## **ADDENDUM NO: 001**

**PROJECT NAME: ARLINGTON GATEWAY MONUMENT**

**PROJECT NO.: 1256.18**

**DATE: 07/15/2022**

**ELECTRICAL DETAILS**

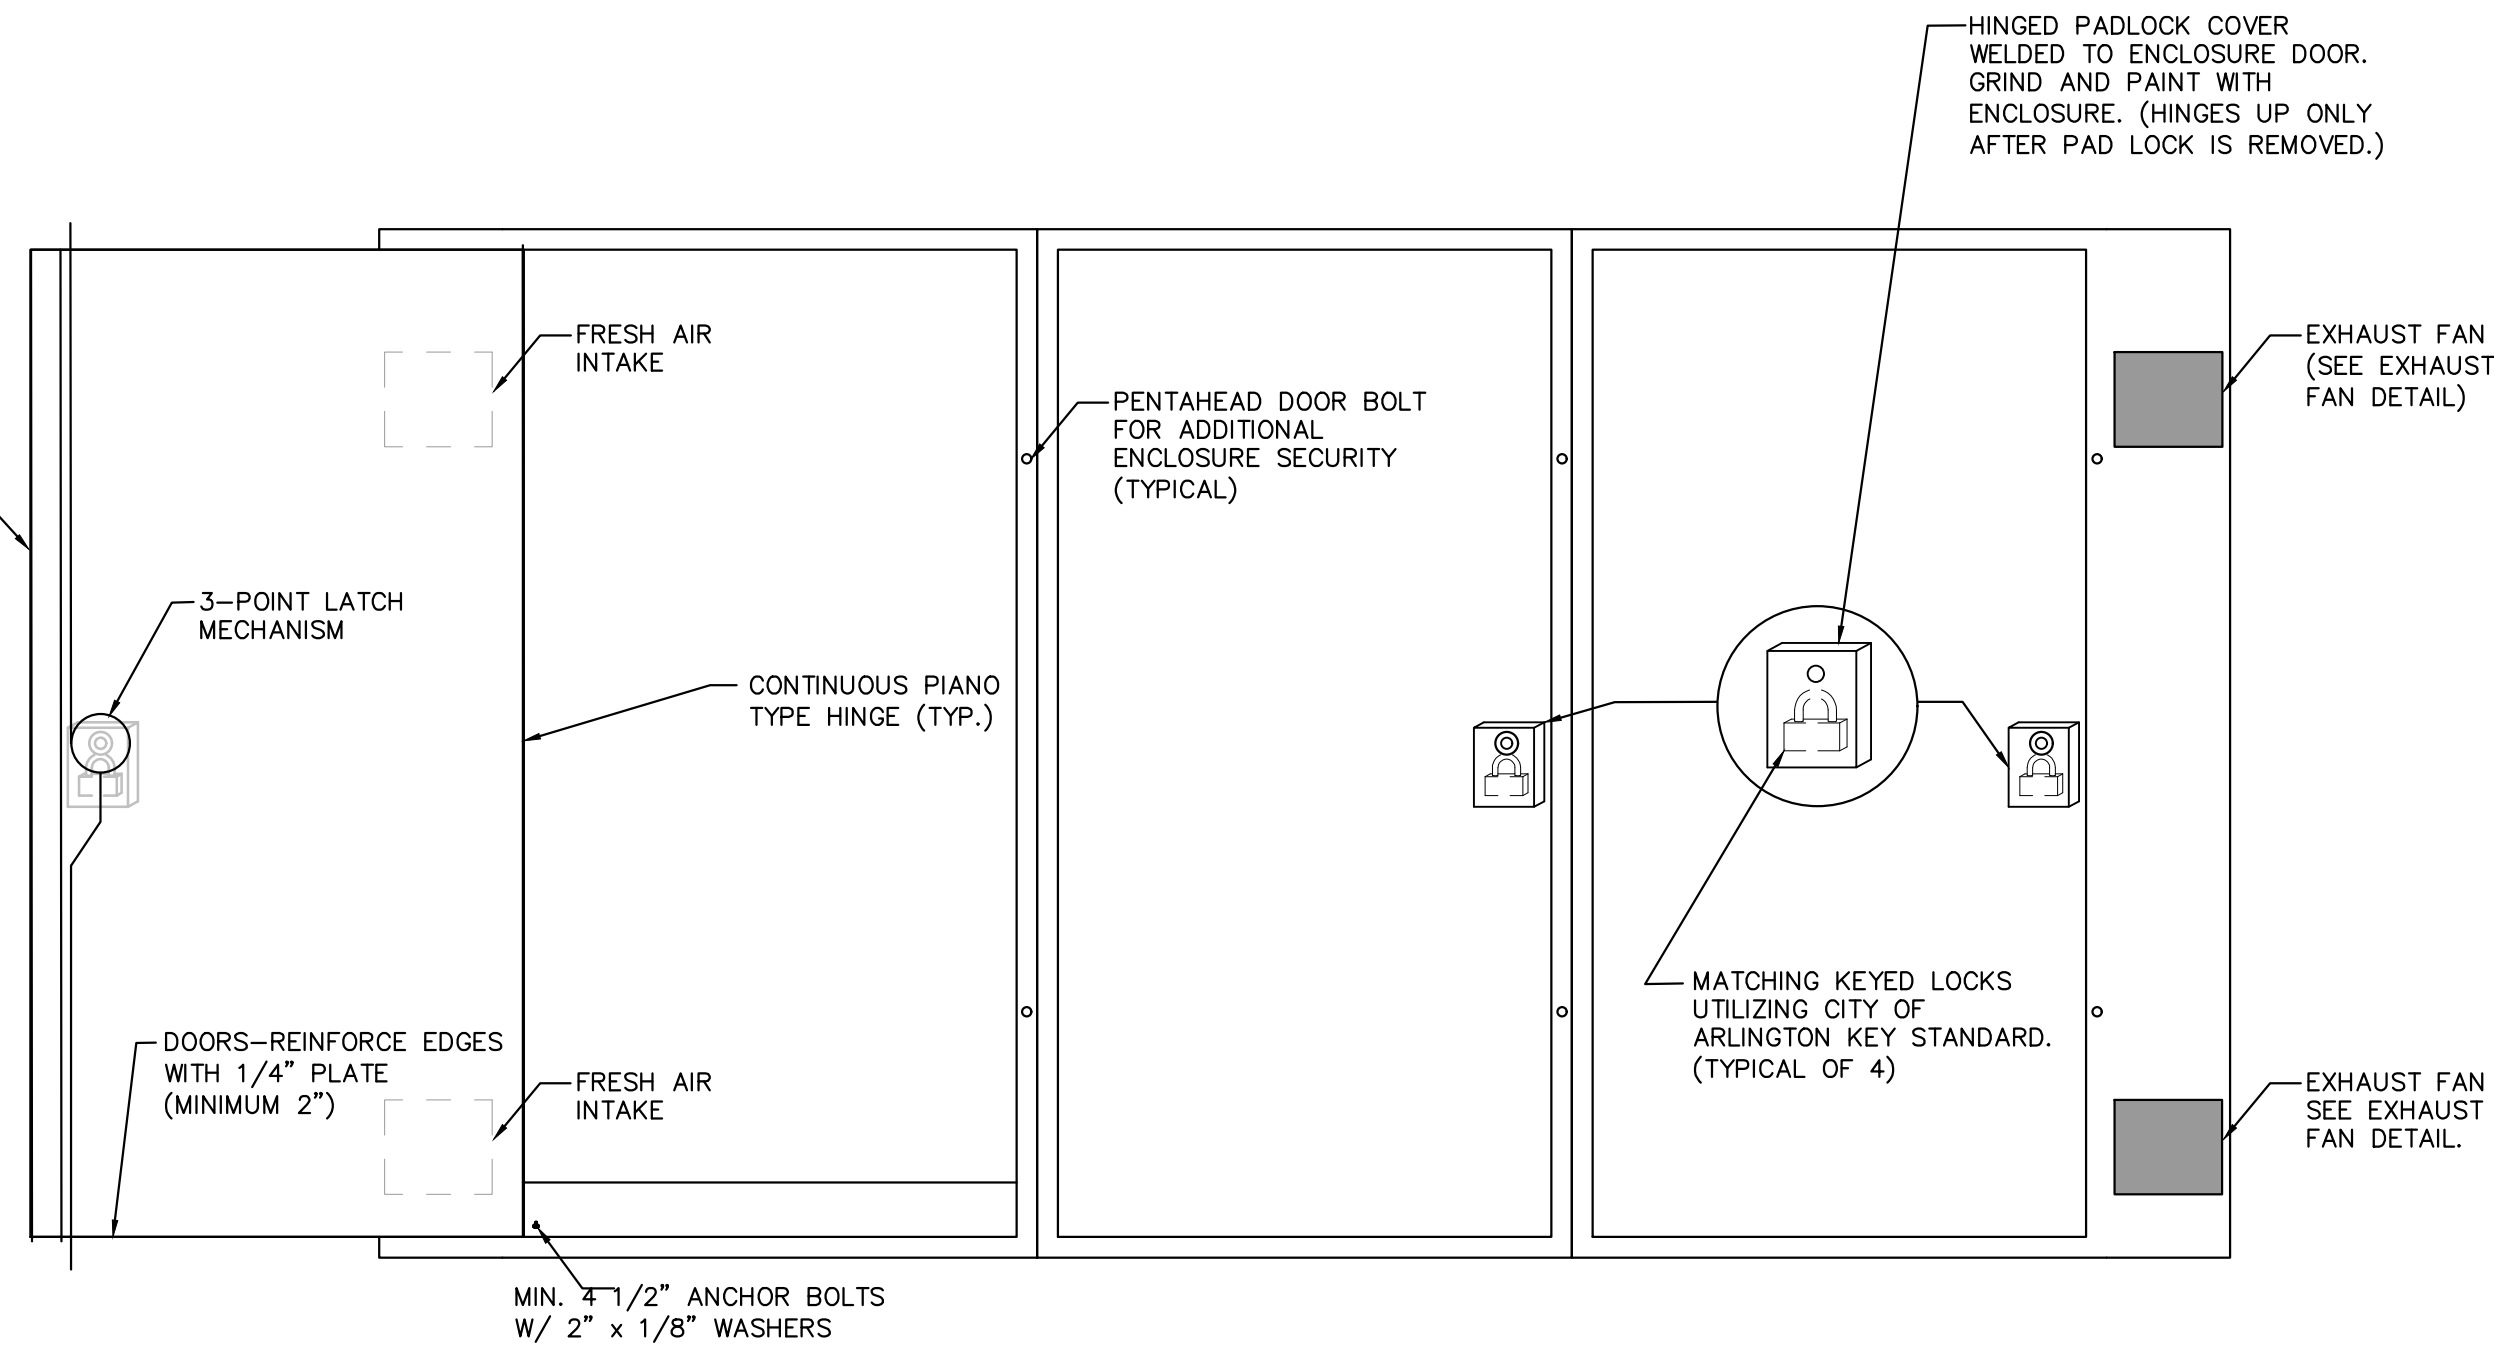
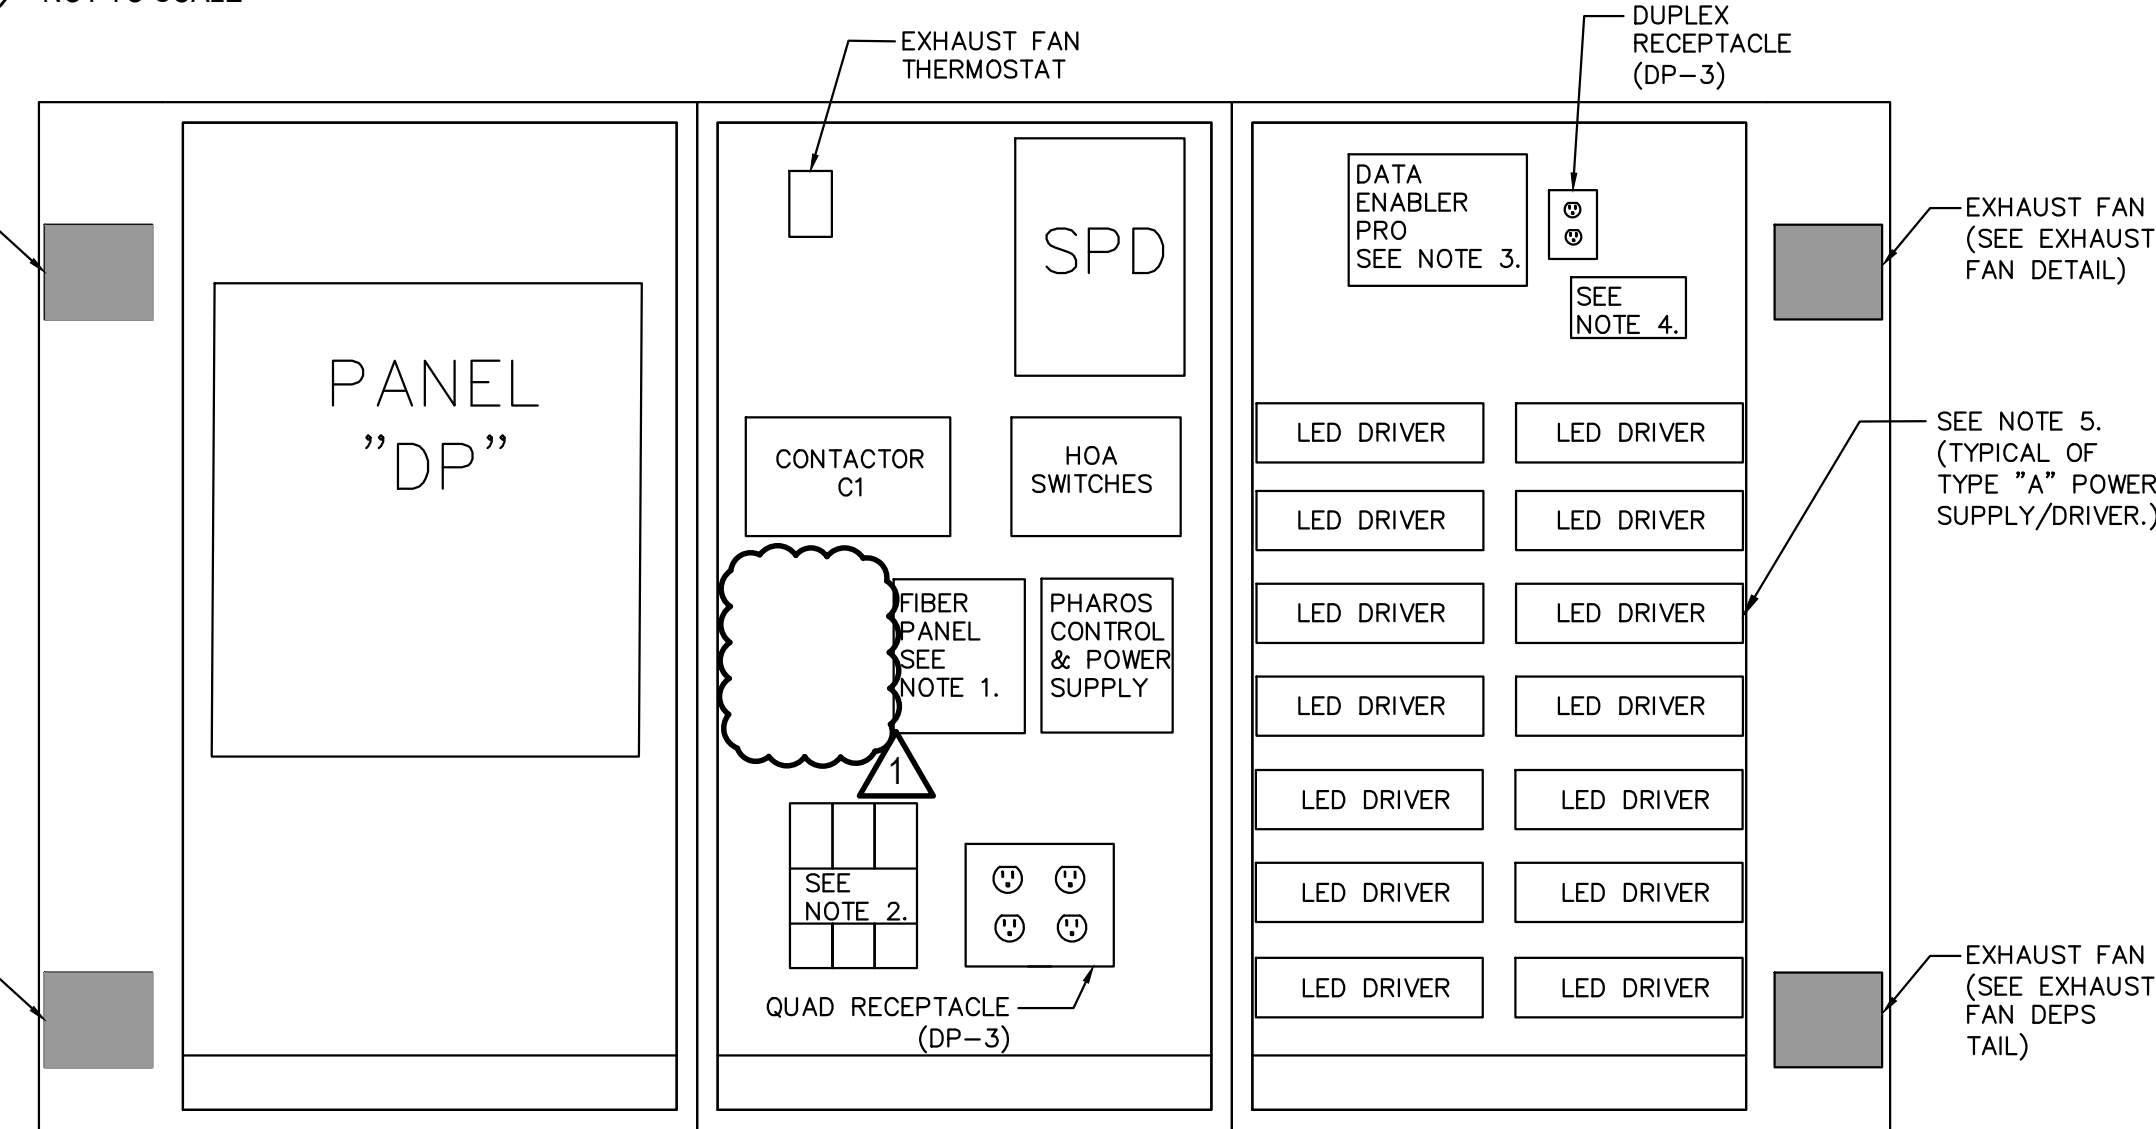
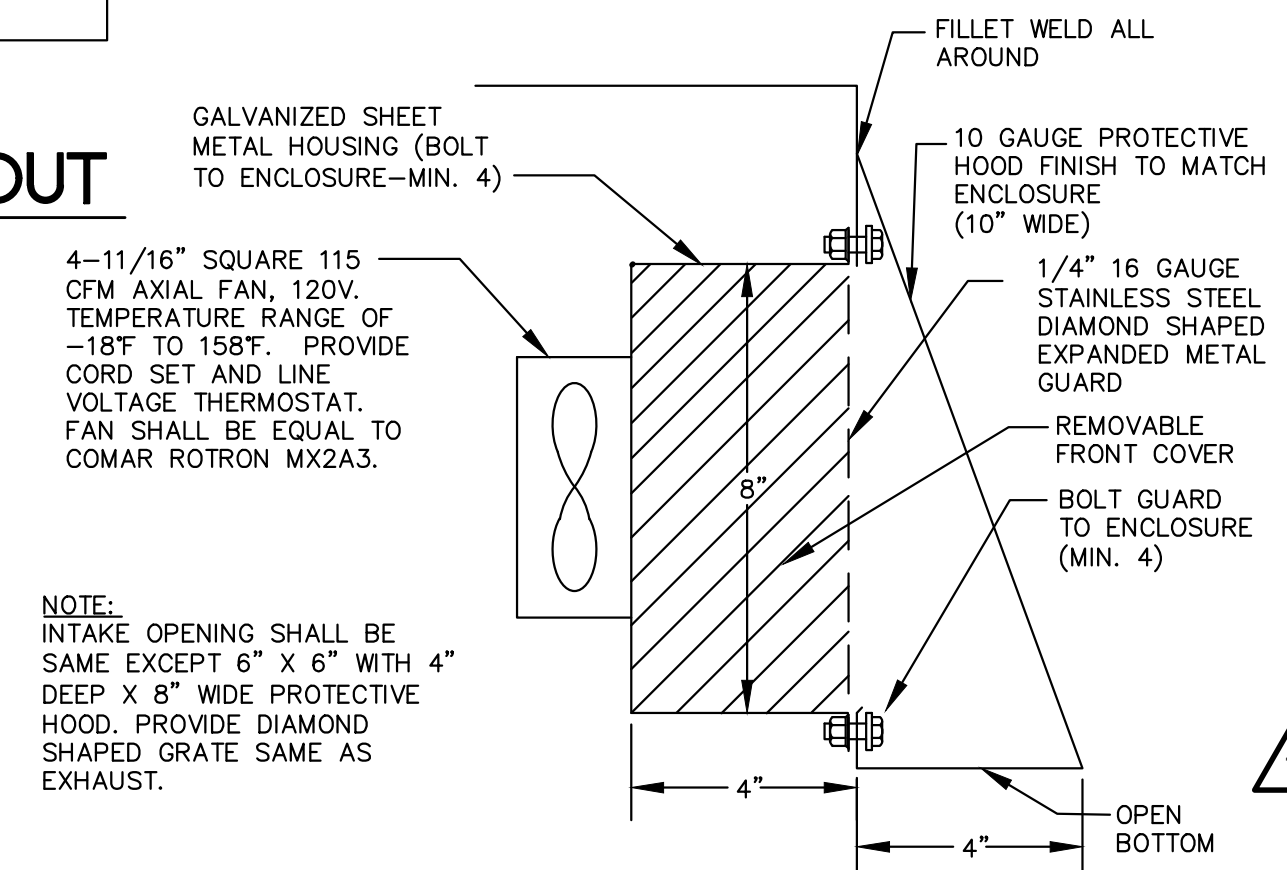
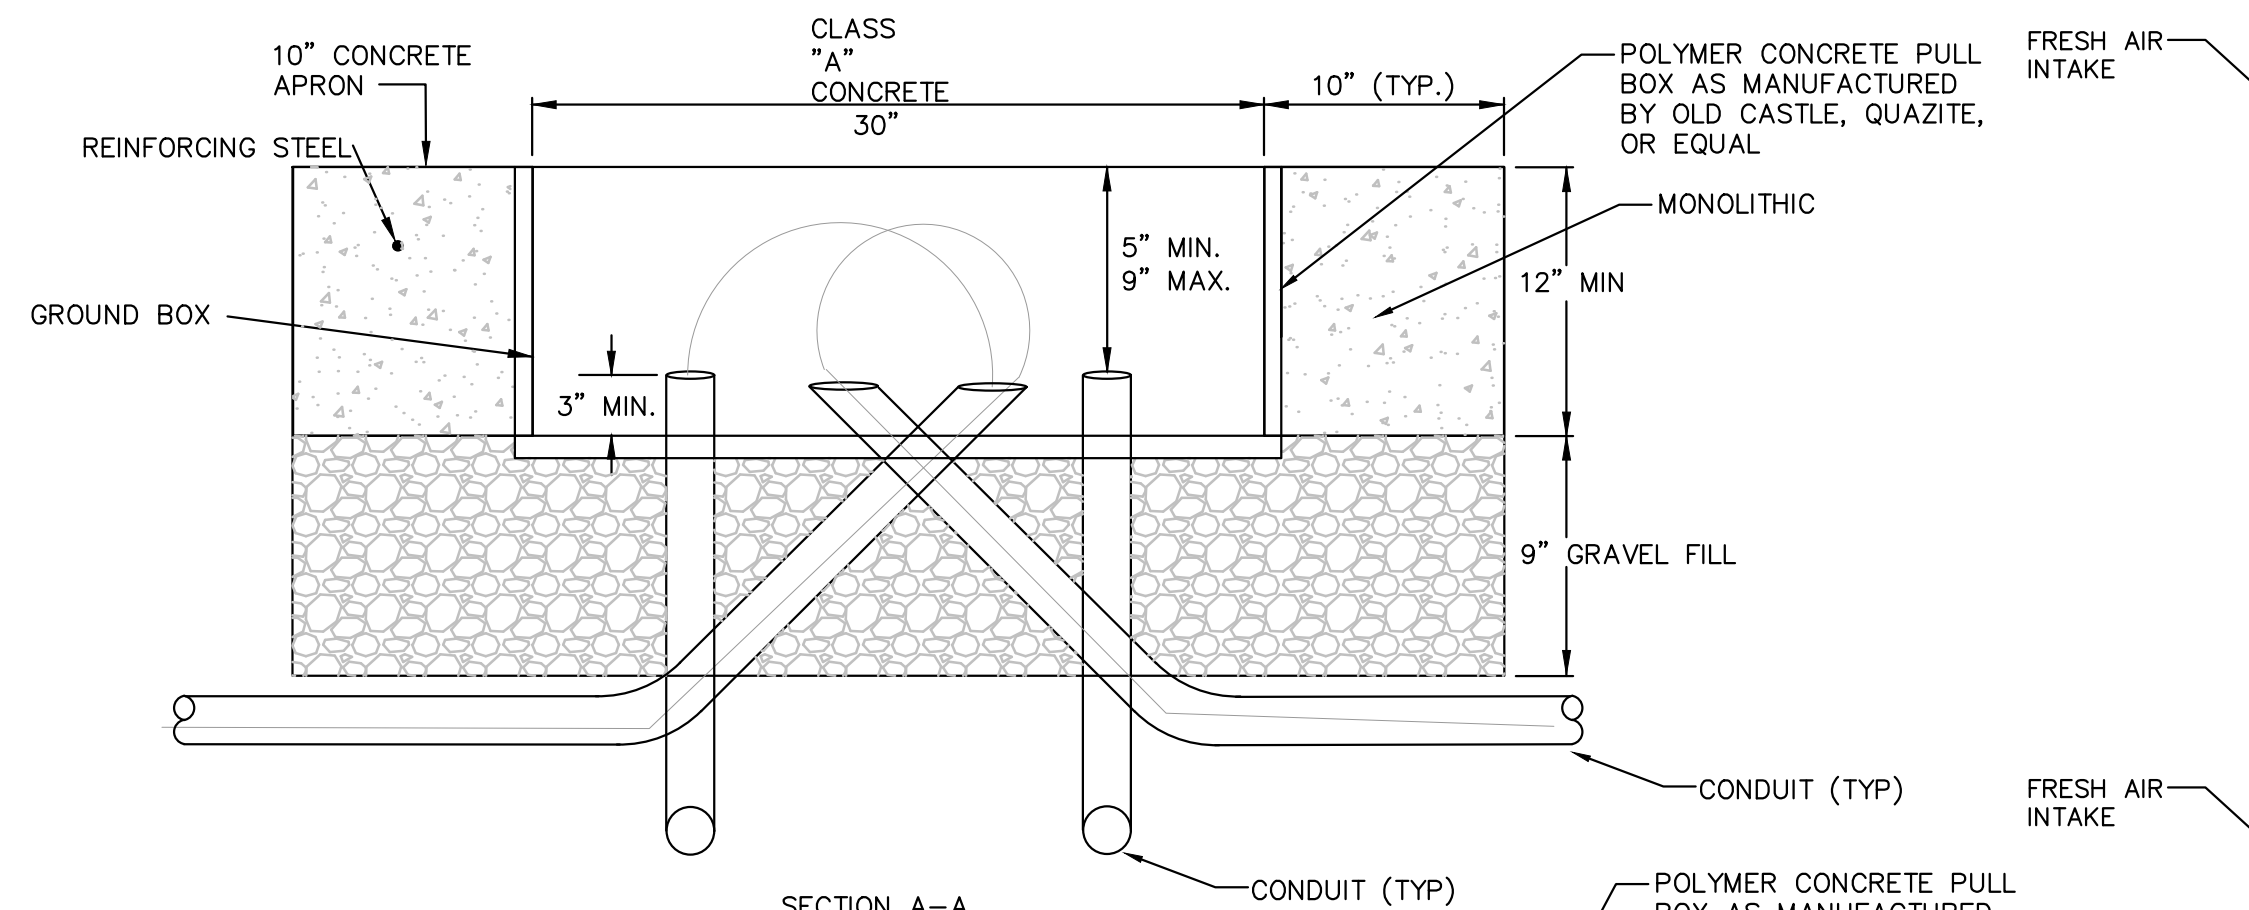
ITEM 1: SHEET 18: Delete and substitute revised drawing, dated 07/15/2022, attached and included as a part of this addendum.

A. Remove touchscreen from scope of work.
